EPC FOR UPGRADATION OF FACILITIES AT SE FIELD			
	COMMENTS RESOLUTION SHEET (CRS)			
Contract No.	4700022908	Project No.	P30377	Comment Code - 2
Document No.		Transmittal No.	Document Title	☐ 1 Approved – No Comments ☒ 2 Approved Subject to Incorporation of Comments ☐ 3 Revise and Resubmit ☐ 4 Rejected ☐ 5 Retained for Information
P30255-14-27-76-1601	Rev A	ATC-4700022908-04458-1	FOUNDATION LAYOUT & DETAIL DRAWING FOR NEW COMPACT SUBSTATION AT WATER TANK FARM - ASAB

PROJECT: REPLACEMENT OF AGED ELECTRICAL EQUIPMENT AT SE FIELD

DRG. TITLE: FOUNDATION LAYOUT & DETAIL DRAWING FOR NEW COMPACT SUBSTATION AT WATER TANK FARM ASAB

DRG. No.	1427761601B	1/2
AREA	P/AREA	DOC. CODE
SERIAL No.	REV.	SH
OF	SH	SH

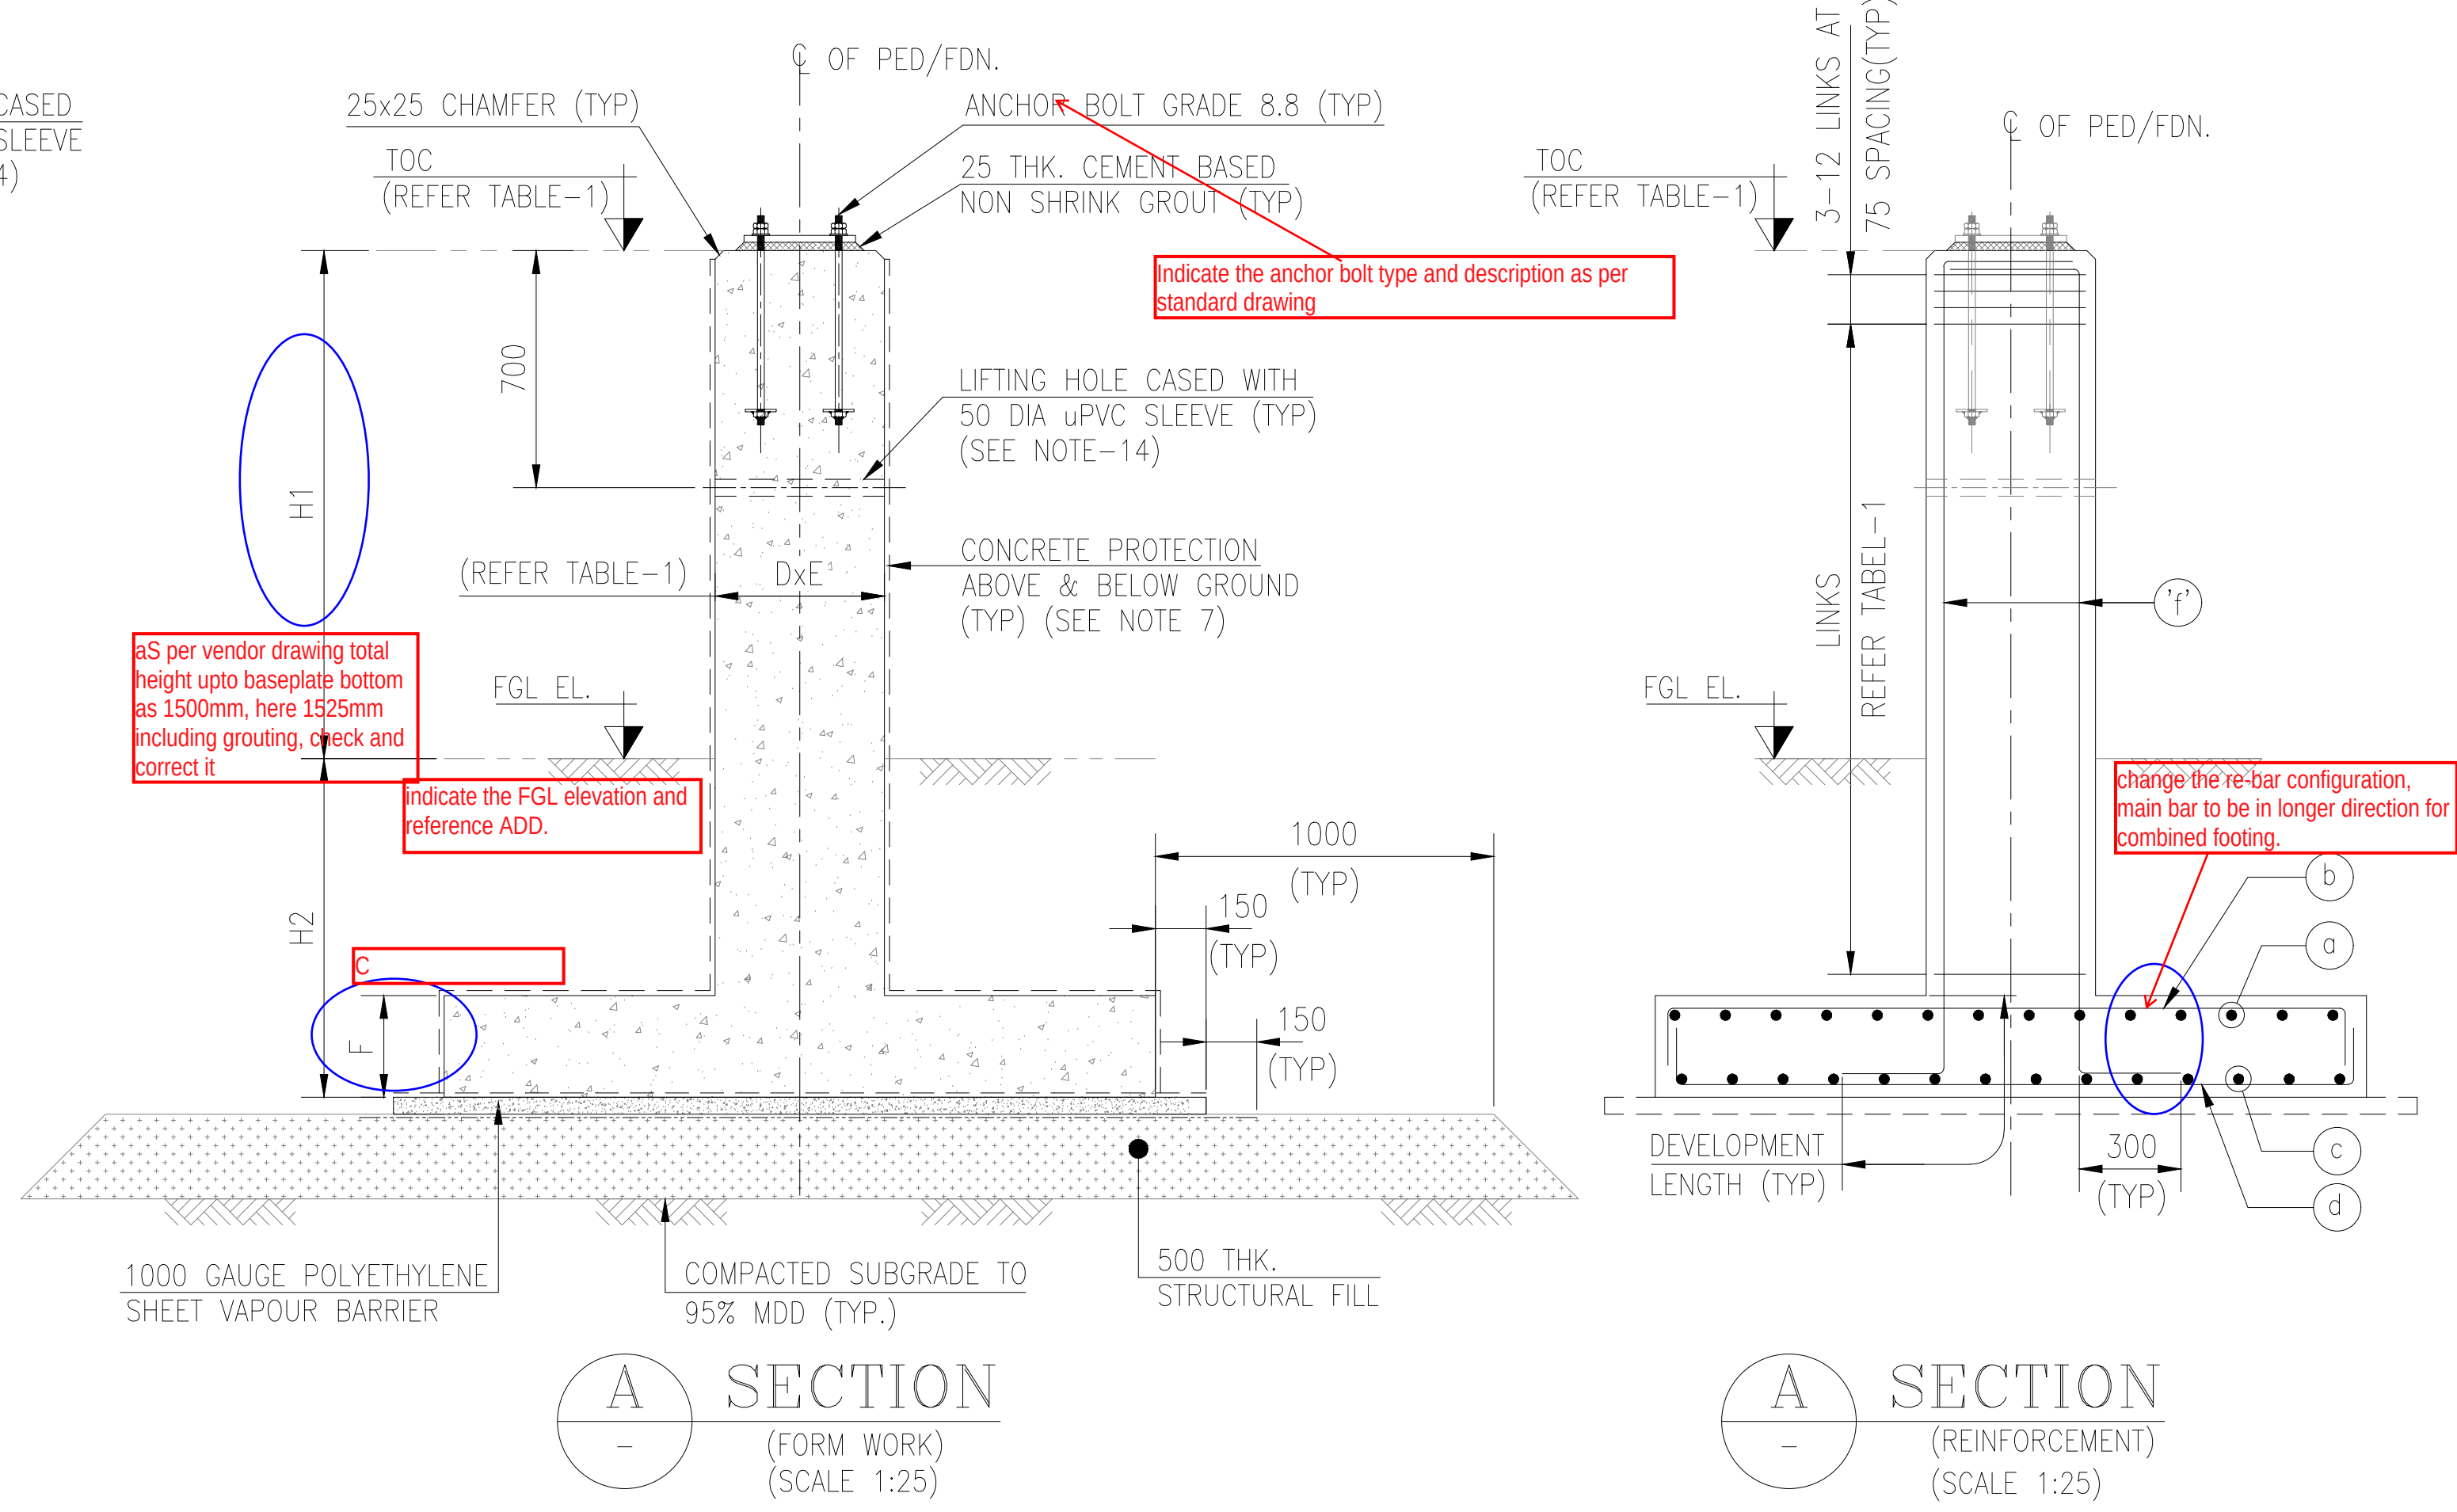
S. No.	Reference / Page No.	COMPANY Comments	CONTRACTOR Response	Status / Remarks
1	SHEET 1	GRID DIMENSION AND CENTRE LINE DIMENSION OF SUPPORT IS NOT MATCHING WITH VENDOR GA DRAWING TYP. GRID LINE AT THE EDGE OF STEEL COLUMN NO AT THE CENTRELINE OF COLUMN, ALL GRIDS AND DIMENSIONS SHALL BE THOROUGHLY CHECKED WITH VENDOR DRAWING AND UPDATED FULLY.	Noted and the drawing is updated as per latest vendor GA	
2	SHEET 1	GRID NUMBER NOT MATCHING DIMENSION NOT MATCHING WITH VENDOR GA, CORRECT IT AS PER FINAL DRAWING, CHECK THE NORTH ORIENTATION WITH PSS VENDOR GA DRAWING	Noted and the drawing is updated as per latest vendor GA	
3	SHEET 1	IS ONLY THIS LIFTING SLEEVE SUFFICIENT FOR FOUNDATION LIFTING, CHECK WITH DESIGN, TRY TO PROVIDE LIFTING LUG ON FOUNDATION INSTEAD PROVIDING SLEEVE ON PEDESTAL TYP.	Noted and updated in the drawing.	
4	SHEET 1	WATER TABLE SHALL BE CHECKED WITH GEOTECH REPORT, ACCORDINGLY PROVIDE THE CONCRETE PROTECTION AGAINST GROUND WATER PROTECTION TYP.	As per Geotech report, no water table encountered.

5	SHEET 1	LIFTING LUG TO BE DESIGN VERIFIED TYP.	Noted and presented

S. No.	Reference / Page No.	COMPANY Comments	CONTRACTOR Response	Status / Remarks
6	SHEET 1	THIS DRAWING IS PRELIMINARY SUBMISSION WITH AVAILABLE INPUTS, SAME TO BE UPDATED AS PER FINAL VENDOR INPUTS WITH PROPER CHECKING AND WITHOUT ANY DRAFTING ERRORS AND HOLD POINTS TO BE UPDATED IN NEXT REVISION WITH FINAL VENDOR INPUTS.	Noted and submitted based on the latest vendor data	
7	SHEET 1	TEXT TO BE IN SAME ALIGNMENT TYP.	Noted and updated	
8	SHEET 1	ALL THE FOUNDATION DIMENSION AND RE-BAR DETAILS, PEDESTAL HEIGHT ARE TO BE VERIFIED AND UPDATED AS PER FINAL VENDOR INPUTS AND MAT 3D DESIGN	Noted and updated	
9	SHEET 1	BOC?	Noted and corrected	
10	SHEET 1	PEDESTAL AND FOUNDATION ORIENTATION SHALL BE AS PER FOUNDATION PLAN TYP.	Noted and updated	
11	SHEET 1	CORRECT THE LEADERS OF FILLS TYP.	Noted and updated

S. No.	Reference / Page No.	COMPANY Comments	CONTRACTOR Response	Status / Remarks
12	SHEET 1	CHECK THE ANCHOR BOLT SCOPE OF SUPPLY PROVIDE THE ANCHOR BOLT DETAILS, SHOW AS PER ACTUAL ANCHOR BOLT LENGTH TYP.	Noted and updated	
13	SHEET 1	NOTES SECTION SHALL BE THOROUGHLY CHECKED AND SHOW ONLY RELEVANT NOTES TYP.	Noted and updated	
14	SHEET 1	REFER DESIGN CALCULATION COMMENTS TYP.	Noted	
15	SHEET 1	PROVISIONALLY APPROVED IN CODE-2 ONLY FOR PROGRESS.	Noted	
16	SHEET 2	REFER SHEET-01 COMMENTS	Noted	
		ORIGINATOR	REVIEWED BY	APPROVED BY
Name		LAVANYA.S	KALAI SELVI	RAHUL PRAFULLA KHANDEKAR
Sign				
Date		10/12/2025	10/12/2025	10/12/2025

The anchor bolt configuration shall be thoroughly verified with respect to the design comments provided in the structural design calculations, ensuring alignment with the considered support conditions. This design drawing must be revised to reflect the final structural design calculations, structural drawings, and foundation input drawings (refer to Company comments). Additionally, ensure the drawing is updated in accordance with the comments provided on the foundation design calculations.

DRG.No.	14	27	76	160	1	B		2/2	
	AREA	P/AREA	DOC. CODE	SERIAL No.	REV.	SHT	OF	SHT

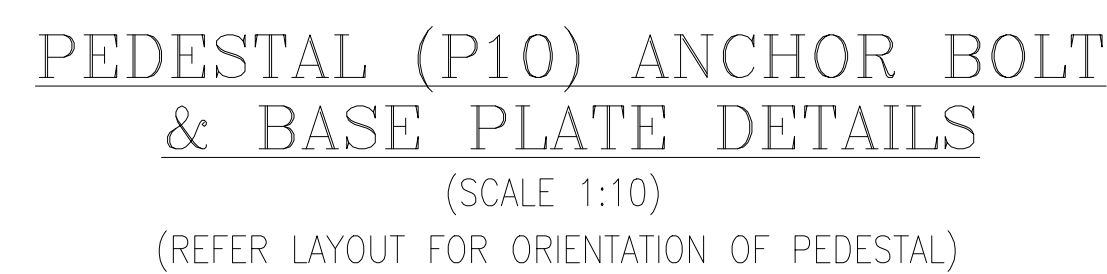
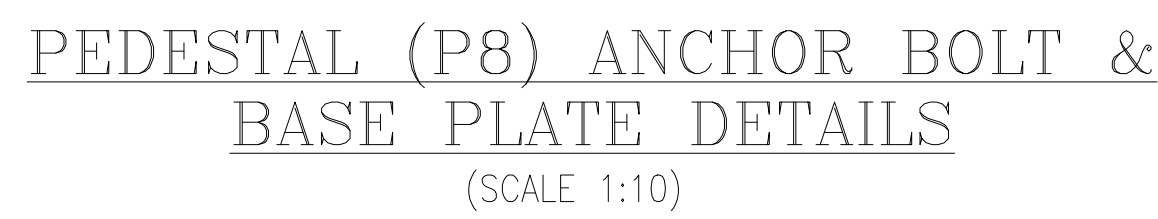
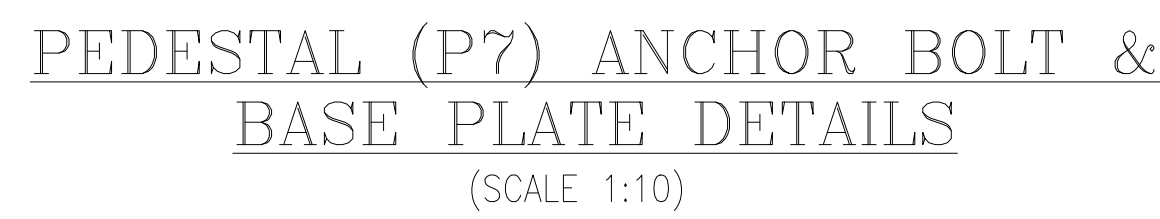
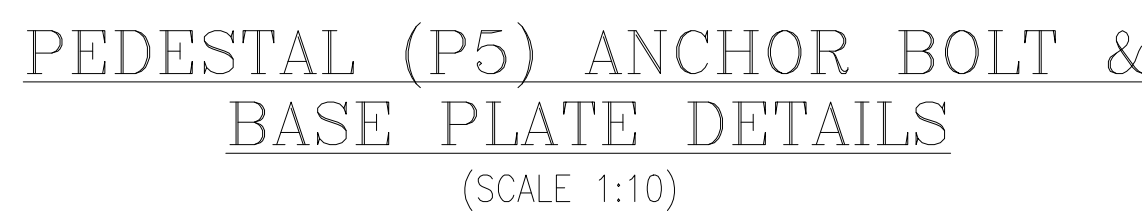
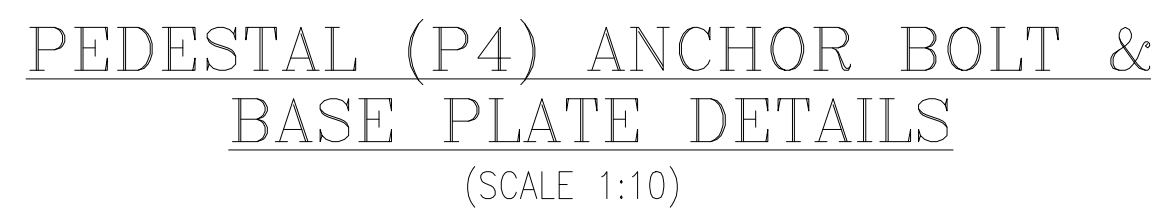
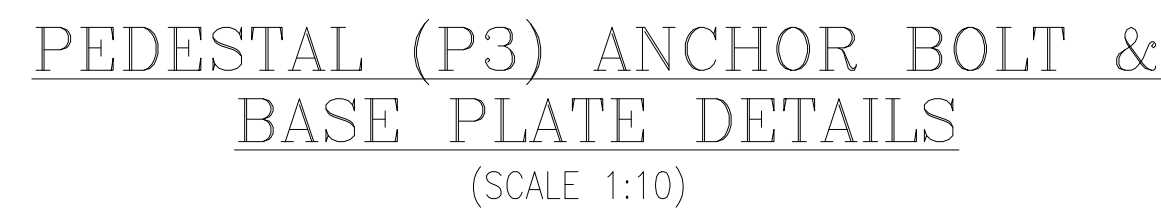
Refer sheet-01 comments
